**SECURED BY DESIGN REQUIREMENTS**

<b>Client</b>	Dar Plus	<b>Secured By Design Requirements</b>
<b>Project</b>	150 Holborn	
<b>Job number</b>	325424	
<b>Site location</b>	150 Holborn	
<b>Date issued</b>	20 November 2015	
<b>Prepared by</b>	Kevin Goldsmith	
<b>Revision</b>	A

The purpose of this document is to clarify our design elements in response to Secured by Design Notes from the Initial meeting on the 30 October 2015 attended by

Fig 01. Excerpt from current Ground floor plan AFP 00 1 200 NTS

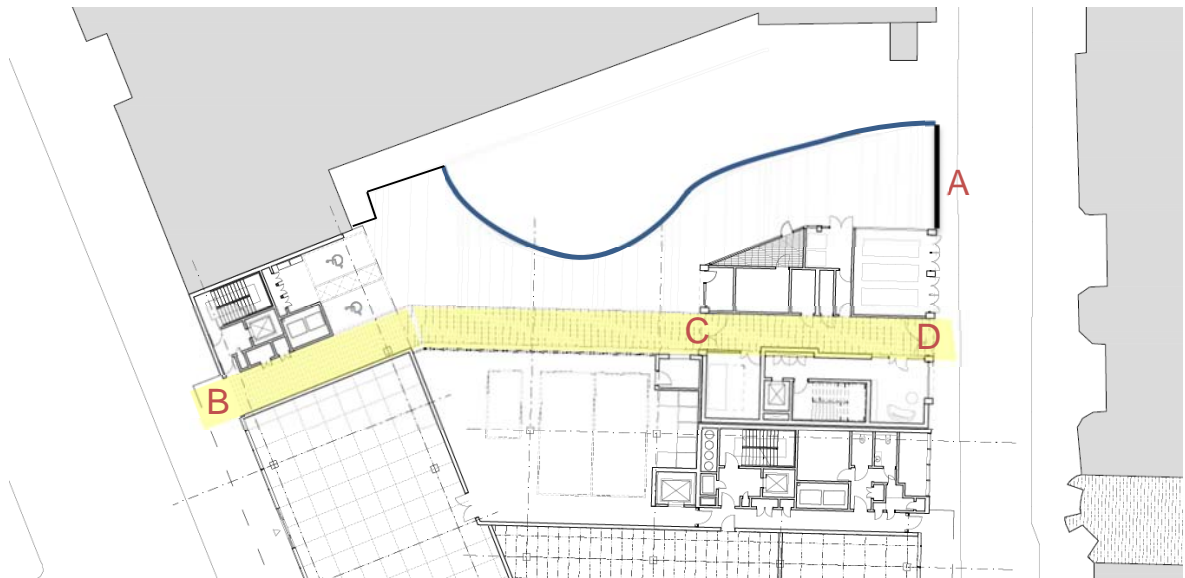
*We discussed a route through the site. Although there would be gating (full height and width), this route would be open to the public to move through the site.*

*This route should not be used by the public. This would lend itself to crime and ASB (anti-social behaviour). Public routes should be along highways, with street lighting, where should an incident occur there is the opportunity for a person to be a witness or intervene.*

*On private land, the area should be controlled to prevent unauthorised people using the area. This route may provide the opportunity for offences such as drugs, prostitution or ASB such as homelessness.*

*Residents should not have to deal with strangers or debris leftover, in private areas. This planning proposal provides the opportunity to improve the security of this site.*

This route has been provided at the request of the planners who want to see reinstatement of a previous route which leads from within the Prudential building to Greys in road and is part of a series of routes/passages

There will be gates installed at points A, B, C, D, gates A will form the barrier to the vehicular access and will only be opened during office hours Monday to Friday when deliveries are scheduled outside these times access control will only allow residents to access the disabled parking spaces, the pedestrian gates will only be open during daylight hours Monday to Friday to secure the residential access, these will also be self-closing with access control to CD only, gate B will be locked when not in use.

There will be CCTV, lighting and other measures to make the space safe and secure. The Lighting is to be installed to BS 5489 and commensurate with the character of the space and will be to BS EN 13201 Table 3, which defines horizontal illuminance and uniformity at face level, with good colour rendering for

JD explained the reasoning for the route through as a request from planning and AL clarified his points re security and inconsistency within planning advice/ policy over the permeability / access verse gated community, AL confirmed that if we met all the measures in terms of gated access control, lighting and other security measures this would be acceptable, he advised that his concern is with Camden planning and not our proposal. It was agreed that we would reduce where possible the recesses to minimise the potential for ASB and provide the security measures as highlighted below to meet or better the standards set out in the Secured by Design standard.

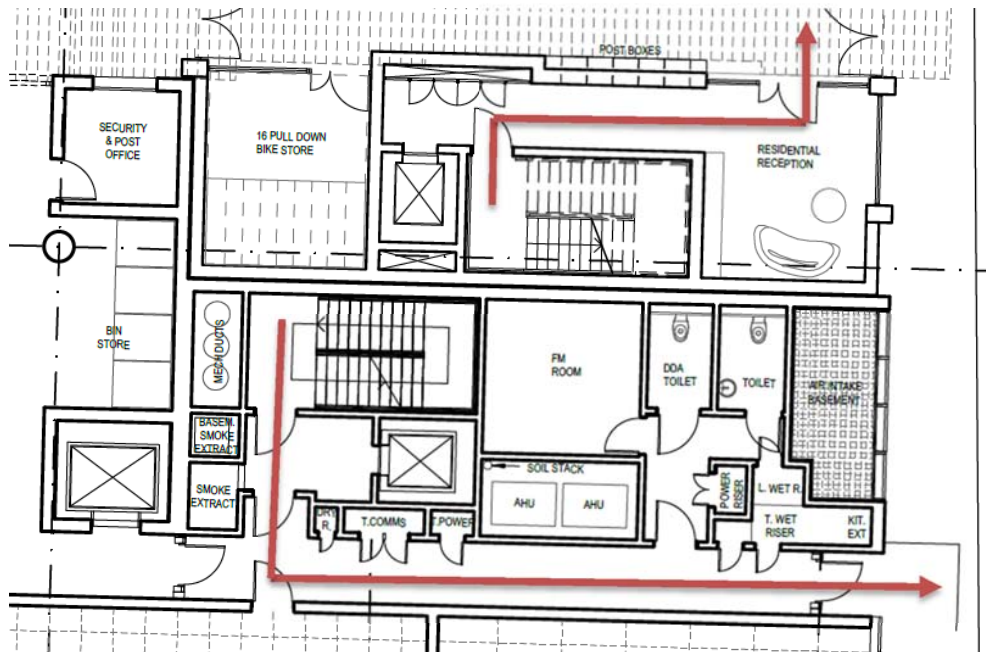
2. *All communal and all residential doors will be to a security enhanced standard such as BS PAS 24-2012, or LPS 1175 sr2 or higher, STS 201, STS 202 BR2.*

It is our intention to have all communal and residential doors meet or better the PAS 24 2012 security standard we shall include reference the PAS requirement during preparation of our specifications and we shall investigate and only select manufacturers that meet these standards during our developed design stage when we start to look at specific products and materials

PBPW confirmed that we will meet the above requirements for doors for the development.

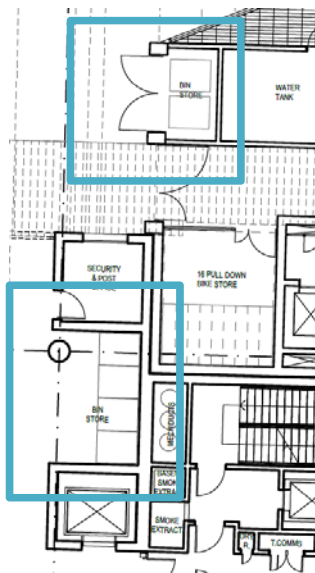
3. Fire escape routes from different areas (office to residential) should not be able to be compromised by activation of an alarm and then gaining entry to another area.

Fire escape routes are separate and will not be compromised by alarm activation which could gain entry to the different areas

PBPW confirmed the routes from residential and commercial no longer compromise each other as there has been a redesign since the initial meeting, AL confirmed that this was acceptable

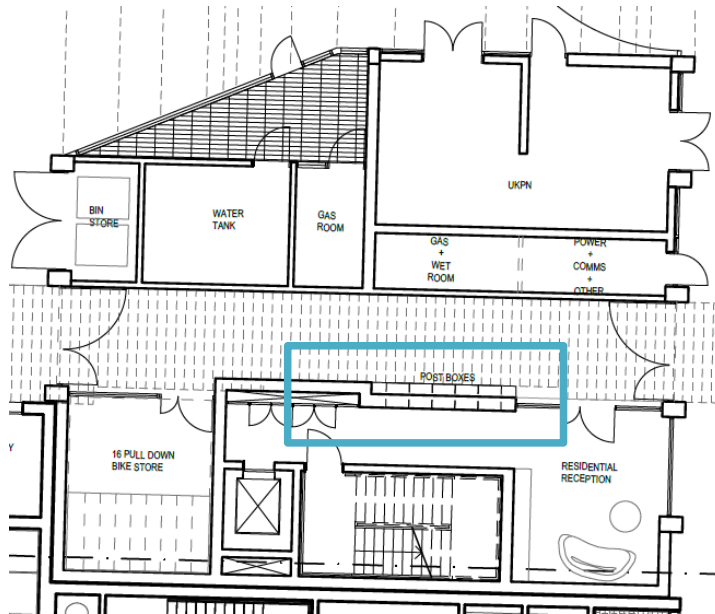
4. *Bin Store self-closing and locking door which is fit for purpose*

We confirm Bin stores to the residential will have self-closing device and a locking door the bin stores within the commercial development will be adjacent to the loading bay, the doors to the loading bay will be secured and fit for purpose.

PBPW confirmed the Bin Stores would meet the AL confirmed that this was acceptable

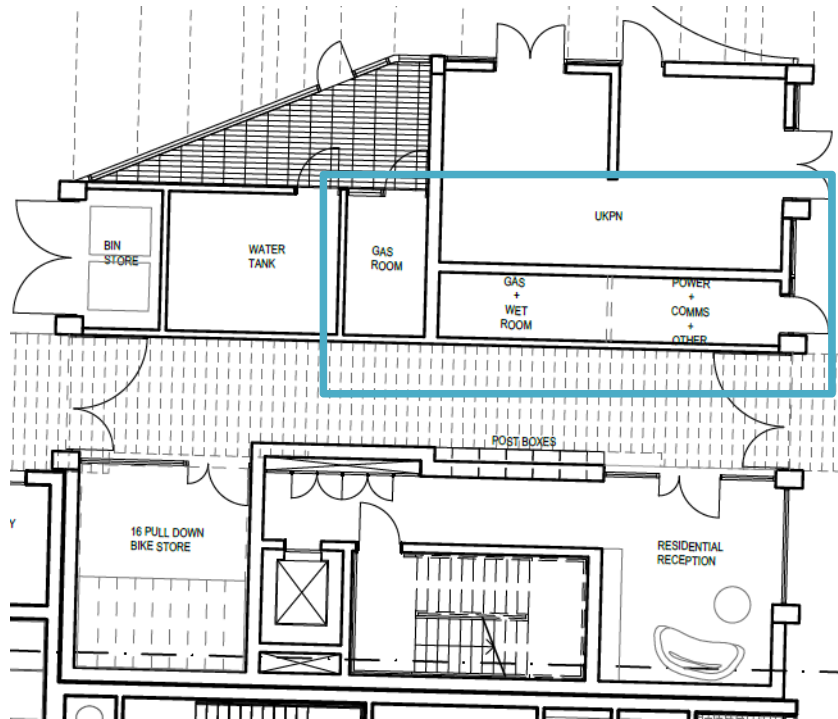
6. *Utility meters will be located in a central location.*

*Utility metres are centrally located and should and do not require access to the residential development*

PBPW confirmed the location of the Utility meters, AL confirmed that this was acceptable

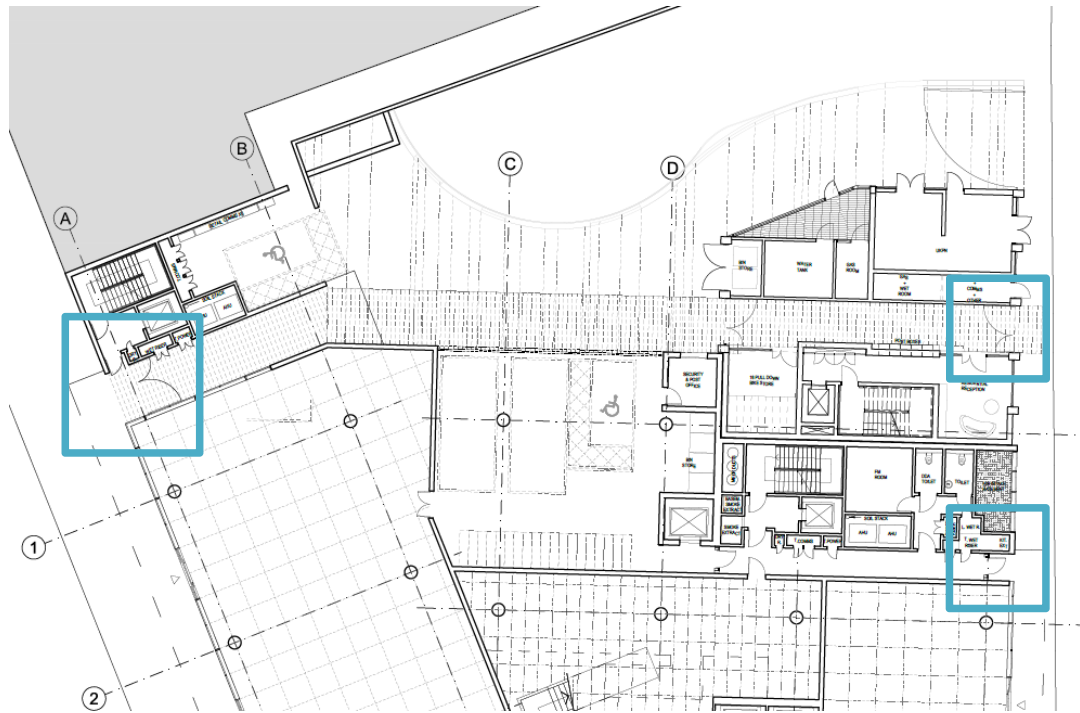
8. CCTV will be registered and comply with the information commissioner's office. [www.ico.org.uk](http://www.ico.org.uk)

CCTV will be installed, this to be registered and comply with the Information commissioner's office and the CCTV code of Practice.

AL confirmed that this was acceptable

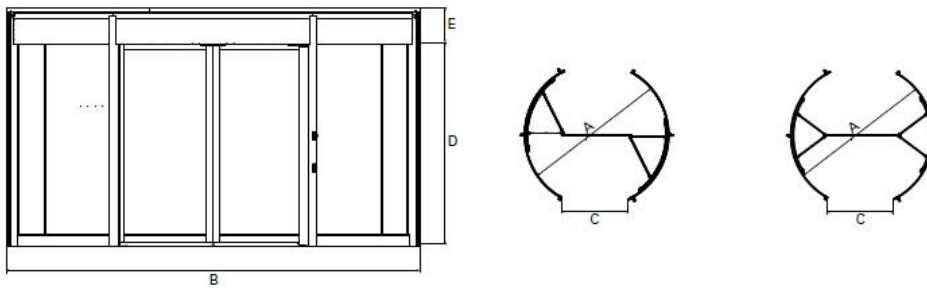
14. *Revolving Door* The revolving door to my knowledge has no security rating. Therefore an internal security line will be defined. There is an open staircase. Although there will be encrypted fob on the lift, a person will still be able to use the stairs.

The revolving door requested by Camden is a Boon Edam Duotour or similar rather than a traditional revolving door and pass door. Night locking is available and would be used as part of the security measures these include Mechanical Locks (door set), electromechanical bi-stable lock

In the event of sub tenancies those floors will be enclosed with glass partitions having no access to the floor only the staircase or lift lobbies or cores.

PBPW confirmed that they would look to install a security line (possible large pocket Door along the line of the Access barriers, They would also investigate whether there is a manufacturer of revolving doors which meet PAS 24 standards to see if these meet the other design requirements for the project, further development on this will be undertaken and forwarded as the design progresses. AL confirmed that this was acceptable
